Report: TAB Report
Function: Test, Adjust, & Balance
Date: 03/12/2026
Completed By: National TAB

02-02-26 QT #1430 SURPRISE, AZ

Project: 02-02-26 QT #1430 SURPRISE, AZ

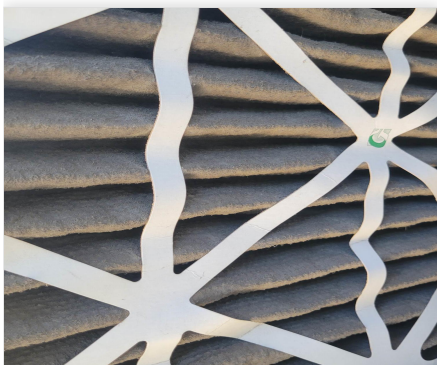
Issue Name : EF3 CURB LEAK
Description : Fan is set for higher than normal, yet flow is too low. Losing quite a bit of air due to improper flange installation at curb.
Created By : National TAB **Assigned To :** National TAB - Dan Hertenstein
Status : Open
Priority : Urgent **Asset Tag :** EF3
Originated Date : 02/25/2026 - Christine Weale - National TAB

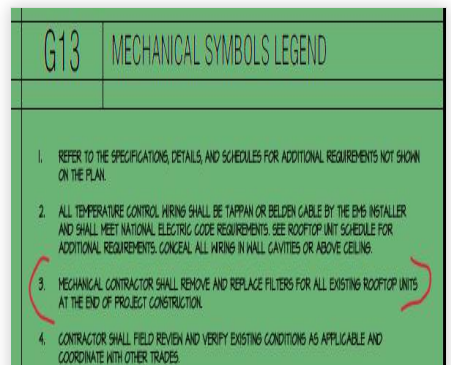
Issue Name : EXTREMELY DIRTY FINAL FILTERS
Description : ALL UNITS: See pics
Created By : National TAB **Assigned To :** National TAB - Dan Hertenstein
Status : Open
Priority : Low **Asset Tag :**
Originated Date : 03/12/2026 - Christine Weale - National TAB

Asset: EF3

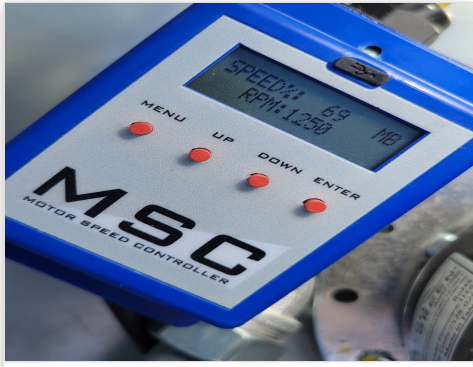
Notes:
LEAK AT CURB, SEE 'REMARKS'.
